U.S. Department  
of Transportation  
**Federal Highway  
Administration**

REFER TO:  
HNG-14

Your December 1, 1988, request for Federal Highway Administration (FHWA) acceptance for use on Federal-aid highway projects of direct burial breakaway fiberglass light poles manufactured by your company has been reviewed. In support of this request you submitted four Southwest Research Institute (SWRI) reports (Project No. 06-2128), dated September 1988, containing pendulum tests on two different poles in "strong" soil. You submitted additional information on March 13 responding to specific questions we posed concerning design details of the poles. The supplemental information also included video tapes and reports of two tests in "weak" soil conducted at your company's facility. Your March 23 supplement covered calculations for using multiple mast arms.

This is in response to your letter of February 20 to Mr. Thomas O. Willett in which you requested Federal Highway Administration (FHWA) acceptance of a 45-foot mounting height for your company's direct burial "BC" series light poles. Our previous acceptance, dated April 4, 1989, included these 47-foot long poles, but the 7-foot embedment

PART NO.	OPAR-15 x 6-HR		
	15' LUMINAIRE ARM		
DWR	DES	SCALE	DATE
D	12/1/77	N	12-11-89
LET	WAS	BY	DATE

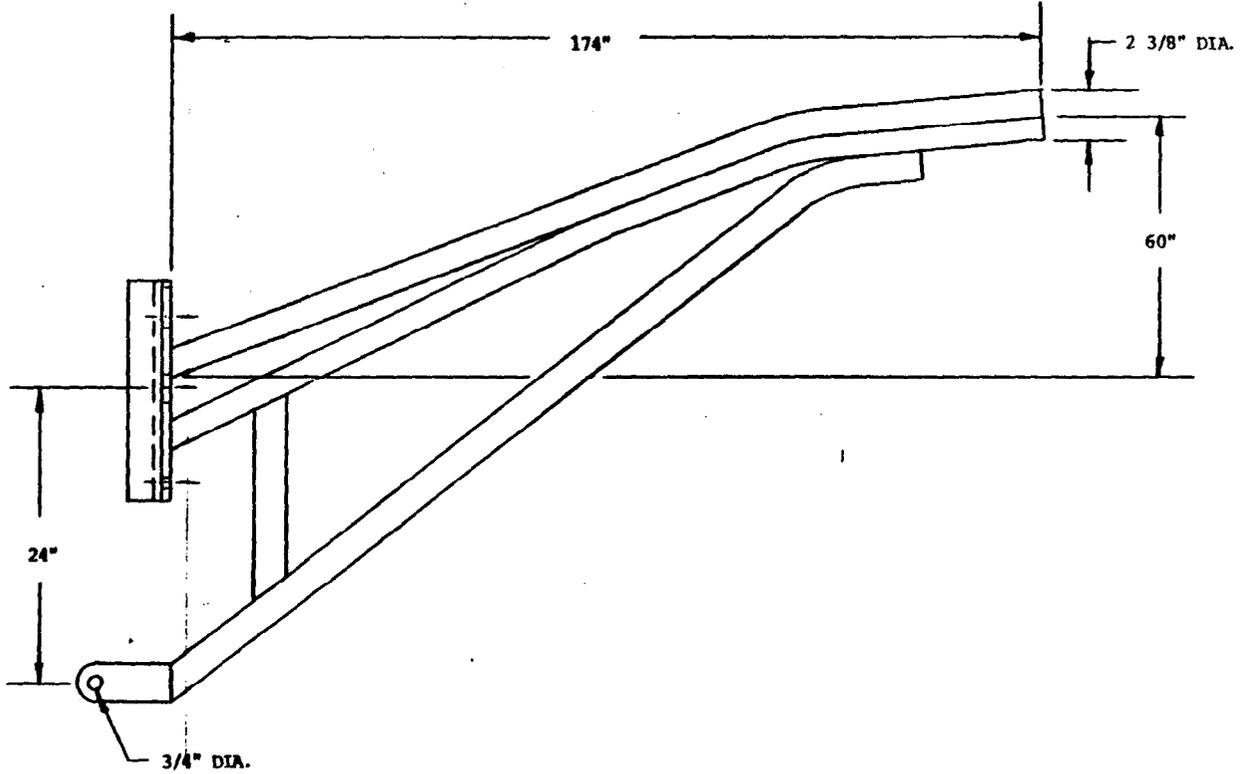
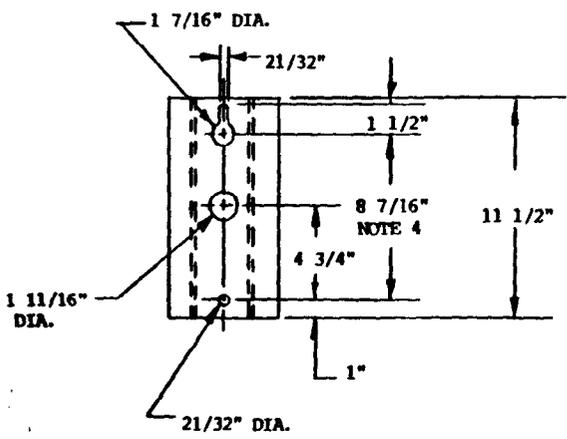
In support of this request, you sent an analysis dated February 7 by Dr. Raymond P. Owings of Rhomicron, Inc., which assumes there would be no significant difference between poles in velocity change under 20 m.p.h. test conditions. This assumption is reasonable since pole dimensions have relatively little influence during low speed crashes--it is the breakaway mechanism itself which causes the greatest portion of the velocity change. The analysis indicated that the expected change in velocity of a 1,800-pound car during a 60 m.p.h. test with an extended BC-47 pole would still be within the 16-foot-per-second limit recognized by FHWA.

We, therefore, concur that the BC-47 pole with a mast arm which increases the luminaire mounting height to 45 feet would be acceptable for use on Federal-aid projects, subject to the same limitations in our April 4, 1989, letter, a copy of which is enclosed for your reference.
